APPLICATION NO.	FILING DATE	FIRST NAMED INVENTOR	ATTORNEY DOCKET NO.	CONFIRMATION NO.
09/756,876	01/10/2001	Yasuo Himuro	Q62523	6217

Office Action Summary

HIMURO, YASUO

With respect to the "auxiliary land part", a colored enlarged copy of figure 1 of Himuro is provided below:

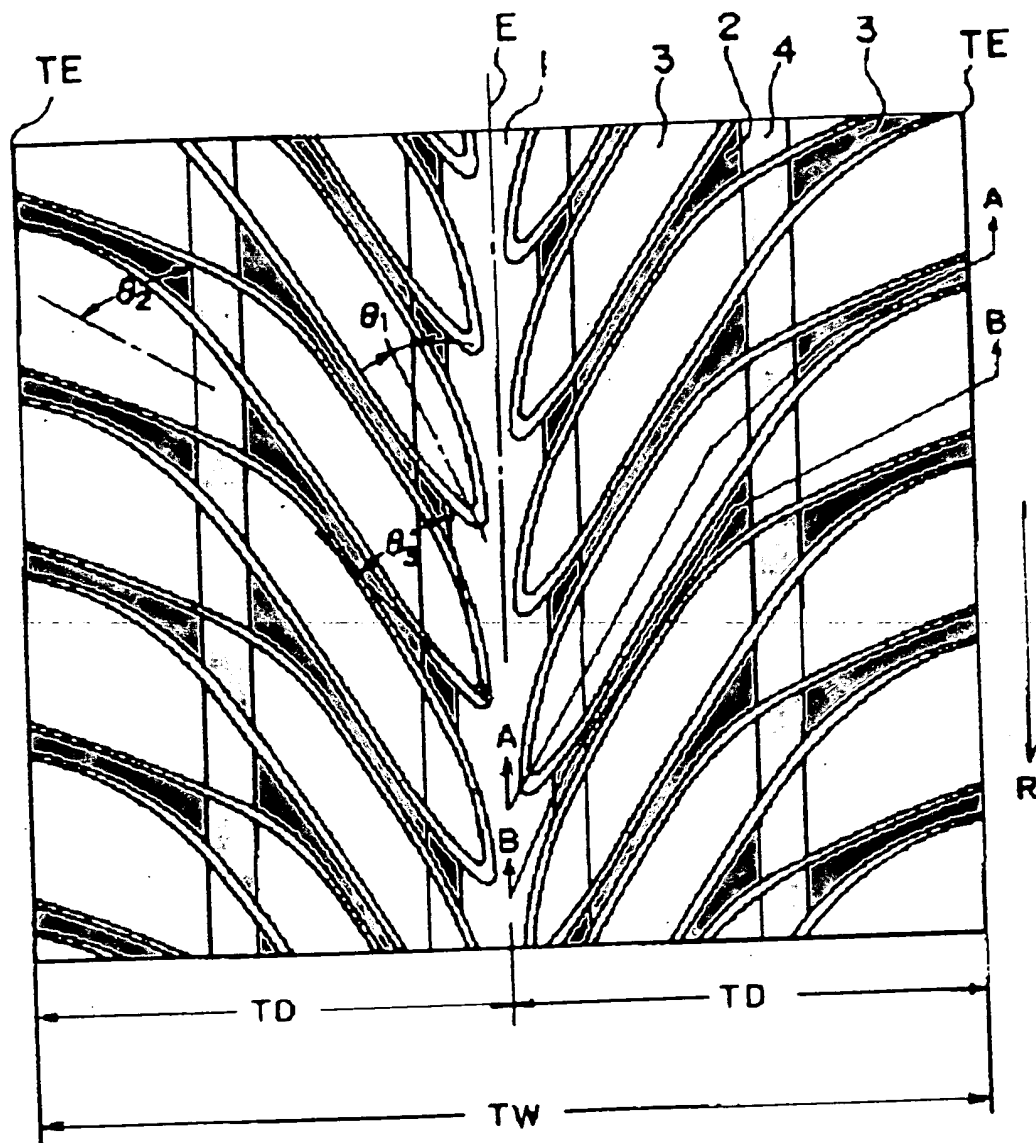
Applicant argues that Himuro fails to teach the "auxiliary land part". The examiner disagrees. The claimed auxiliary land part reads on the portion of the protrusion of the rib 1 having the gradually decreasing height.

The yellow, blue, orange and pink colors were added by the examiner. The ground contacting face of the rib 1, the blocks 2 and the blocks 3 is colored yellow. The slant grooves (the low height portions of blocks 2, 3) are colored blue. The first auxiliary land part is colored orange. The second auxiliary land part is colored pink.

Applicant argues that the seemingly steeply sloped portions of blocks 2, 3 define sides to circumferential grooves and have nothing to do with the gradually sloping auxiliary land part in claim 1. Applicant's argument is off point. The auxiliary land part in claim 1 reads on the portion of the protrusion of the rib 1 having the gradually decreasing height which is colored orange in the above colored applicant's figure 1.
